**AGENDA**  
**CITY OF CEDAR FALLS, IOWA**  
**PLANNING AND ZONING COMMISSION MEETING**  
**WEDNESDAY, AUGUST 23, 2023**  
**5:30 PM AT CITY HALL, 220 CLAY STREET**

**TO:** Planning and Zoning Commission  
**FROM:** Michelle Pezley, Planner III  
**Matthew Tolan, EI, Civil Engineer II**  
**DATE:** August 23, 2023  
**SUBJECT:** MP23-003: Revision of Arbor's Master Plan

**TO:** Planning and Zoning Commission  
**FROM:** Michelle Pezley, Planner III  
           Matthew Tolan, EI, Civil Engineer II  
**DATE:** August 23, 2023  
**SUBJECT:** Revision to the preliminary plat for The Arbors subdivision

PROJECT NO.: 5622  
SHEET NO.: 6 OF 7

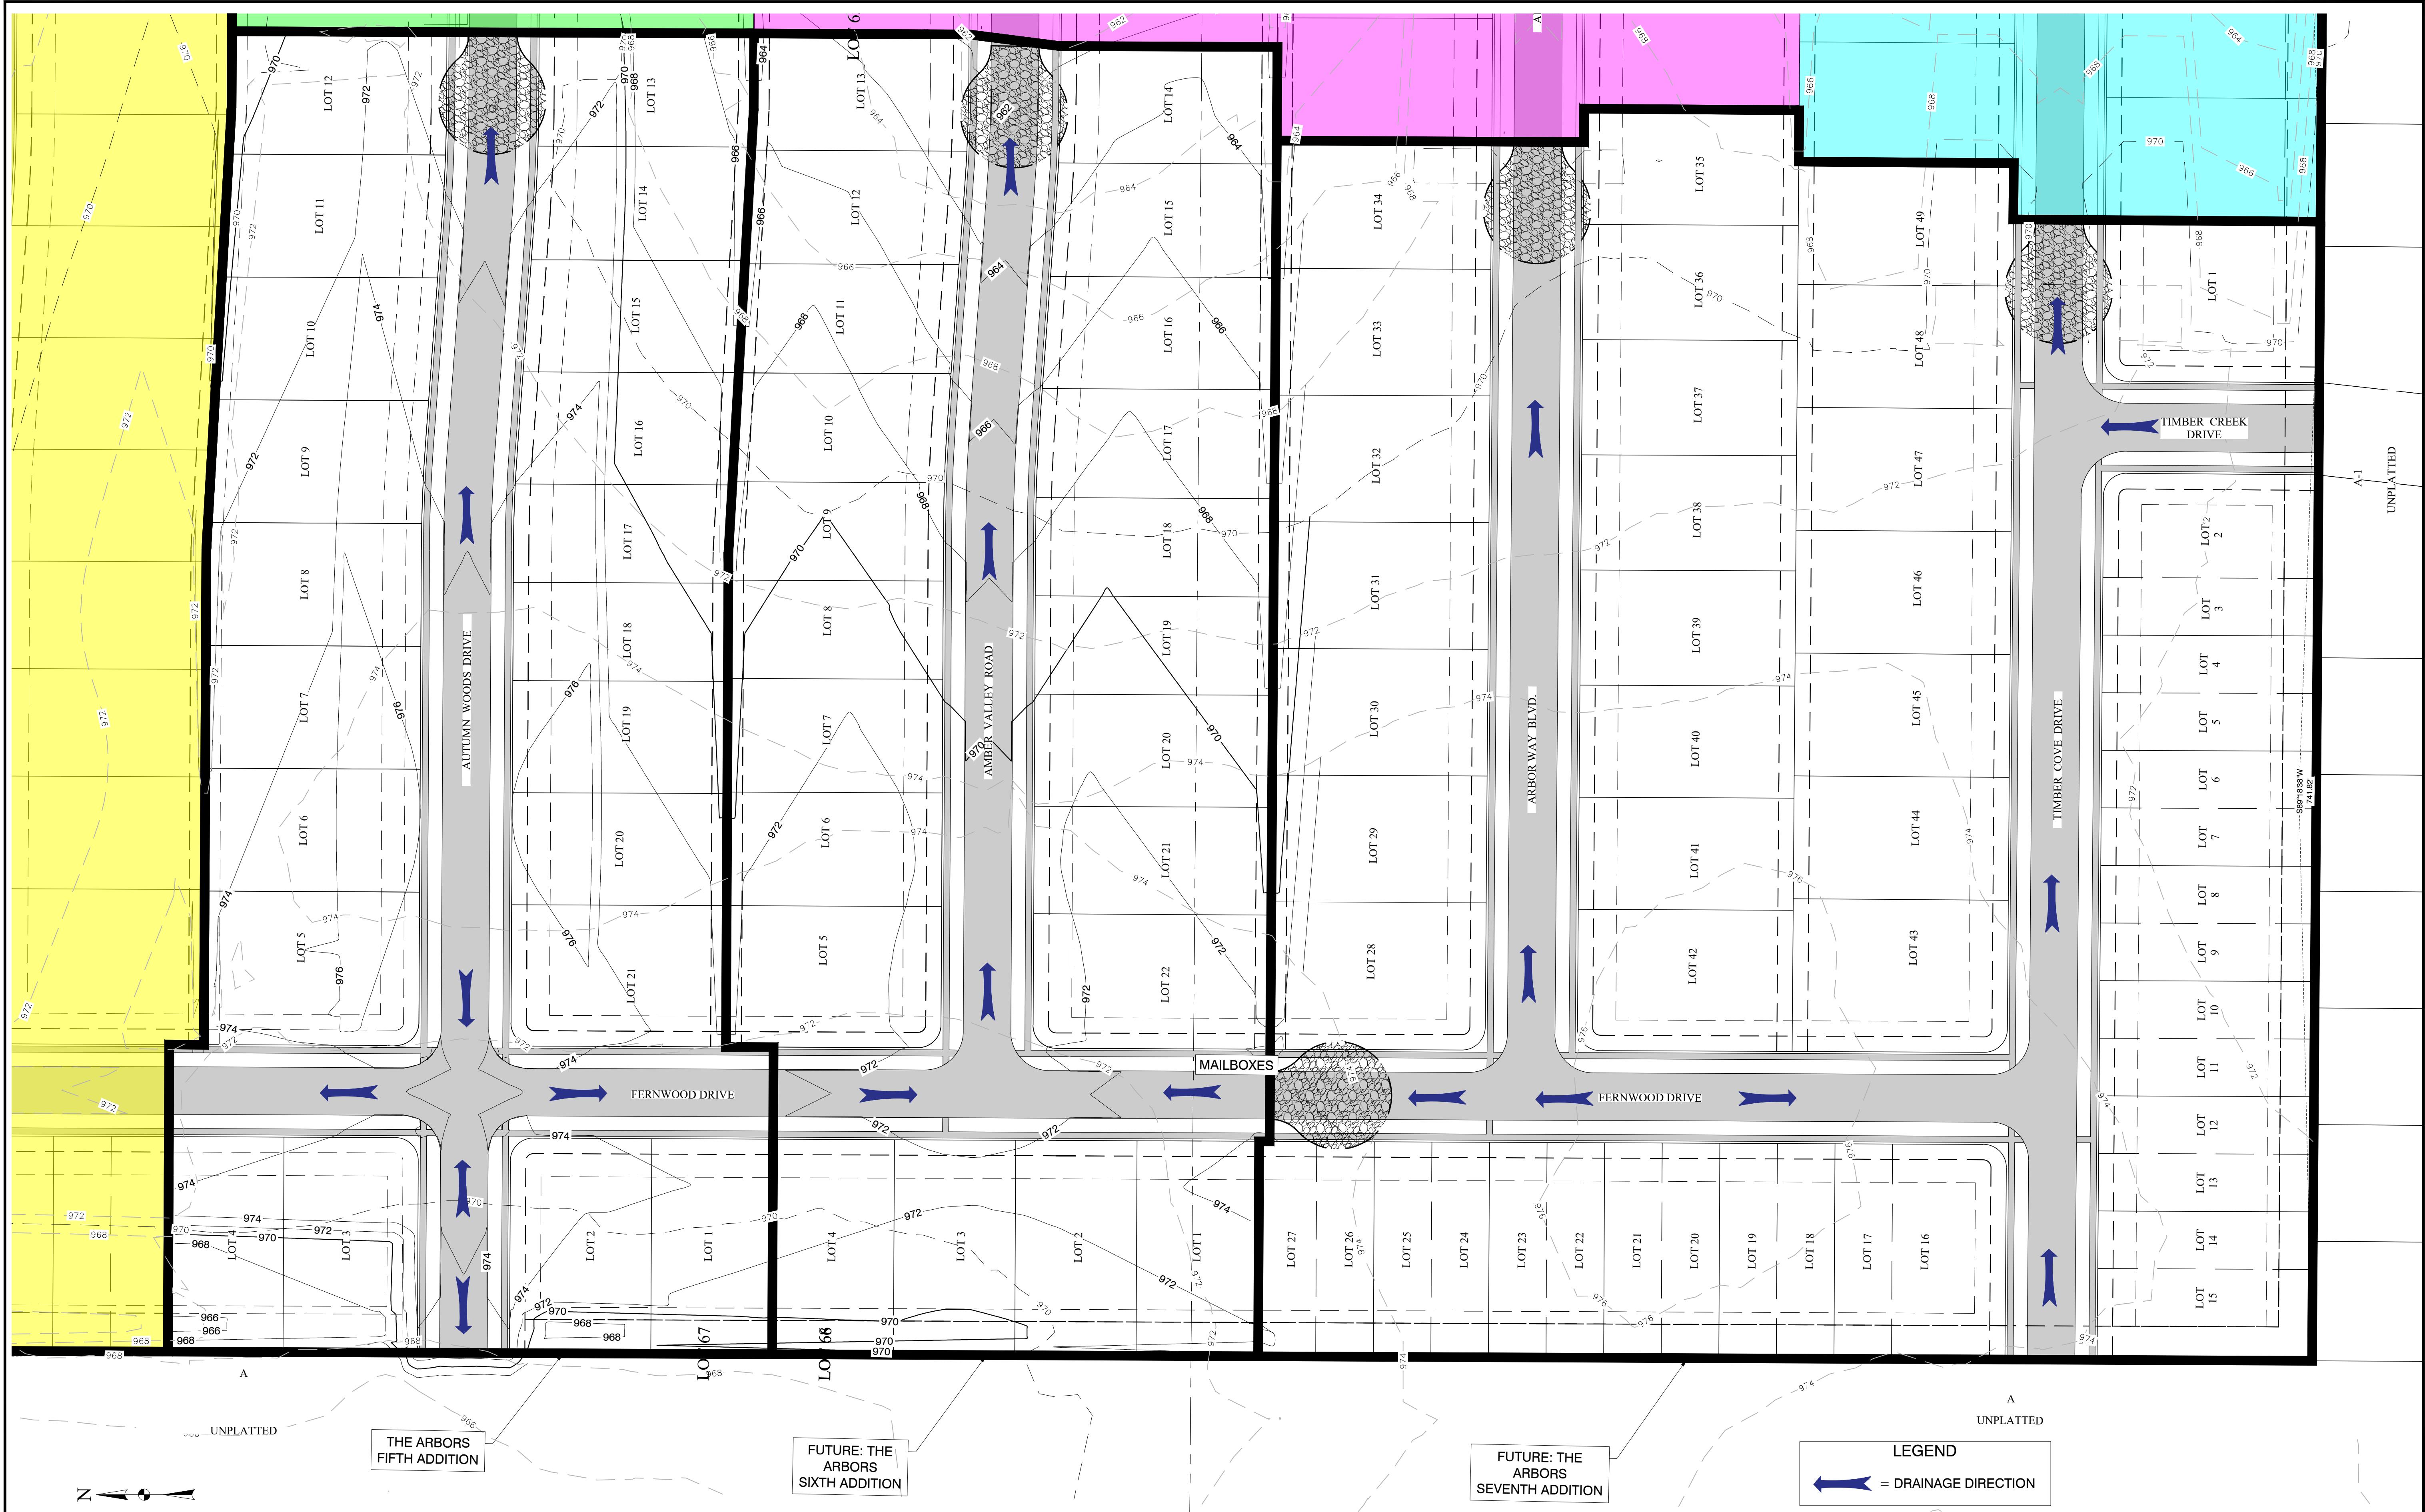
The applicant requests another amendment to the preliminary plat that converts 10 bi-attached dwelling lots to 5 single family detached lots. They are also requesting to split Phase 5 into two smaller phases, which will result in a total of seven phases.

Cedar Falls Utilities (CFU) has reviewed the revised Preliminary Plat for the Arbors 5th, 6th, and 7th Additions Water, electric, gas, and communications utility services are available in accordance with the service policies of CFU. The developer is responsible for the construction of a properly sized water system from the existing 8" & 12" water mains on Autumn Woods Dr, Amber Valley Rd, Arbor Way Blvd, and Timber Cove Dr. Included in the installation are valves, fire hydrants and water service stubs for the new lots. Water main sizing and fire hydrant and valve placement locations will need to be modified. This will be done as a part of the construction plan review. The developer will need to make refundable investments for the installation of the electric and gas utilities to and throughout the addition. For a ten-year period after the installation, CFU will refund a portion of the refundable investments based upon the number of new service connections to the electric and gas distribution systems. There is no interest paid on the refundable investments and the total refunds will not exceed the original investment amounts. CFU will install the communication utility fiber system to serve the addition. The developer is responsible for the cost of the streetlight installations required for any City streets.
